**PZ&B Staff Combination Memorandum: Landmarks Preservation Commission and Town Council**

**SUBJECT:** COA-24-003 (ZON-24-021) 800 SOUTH COUNTY RD (COMBO)

**MEETING:** JANUARY 17, 2024 LPC  
FEBRUARY 14, 2024 TOWN COUNCIL

The applicant has submitted plans, entitled "Hardscape and Exterior Door Alterations and Bridge Addition for Ann DesRuisseaux", as prepared by Brasseur & Drobot, received, and dated by the Town as December 7, 2023. This project is also for a tax abatement.

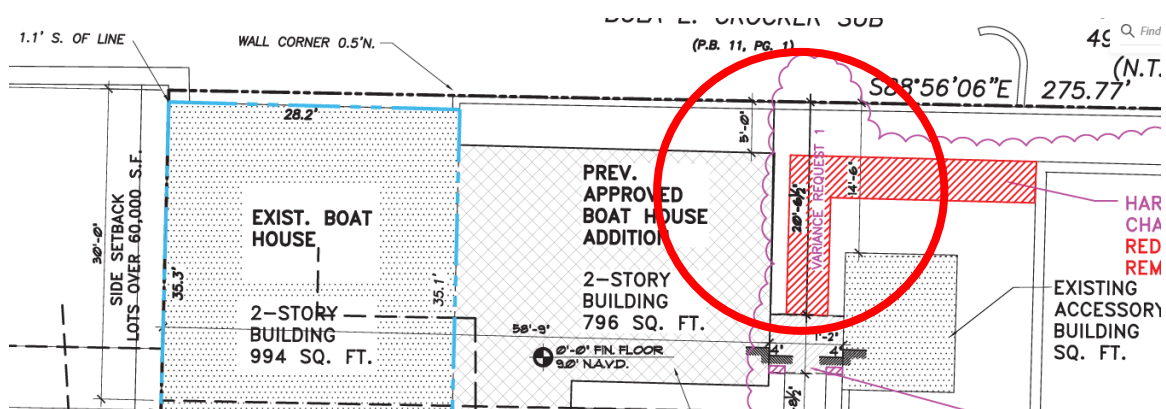
The applicant is seeking a Certificate of Appropriateness and a tax abatement amendment for exterior alterations to a landmarked property. Specifically, fenestration changes and the addition of an uncovered bridge connecting the boat house and generator building. The window and door changes are nominal and in keeping with the existing architectural style. The changes also appear to not adversely impact original elements of the buildings. The proposed bridge requires a variance for its side setback and lot coverage. However, it is only approximately 41 SF, could be removed in the future and there is another bridge on site. The design of this bridge is simple and does not compete with other architectural elements on site.

As it pertains to VARIANCE 1, to reduce the required side (north) setback by 9.5' in order to construct the elevated walkway in between two detached structures with existing nonconforming setback. The existing landmarked building has a nonconforming north side setback which varies from 1.1' to 5' to 14.5'. This small 7'2" wide bridge is a negligible element within a greater nonconformity.

As it pertains to VARIANCE 2, to further increase the nonconforming lot coverage. The 41 SF addition will increase the lot coverage by 0.07%. The lot coverage increase is triggered by the elevated walkway, ie bridge. This covered element counts towards the lot coverage. It must be noted that the applicant has made effort in this area to increase the overall green space by removing some side walkways in this immediate area.
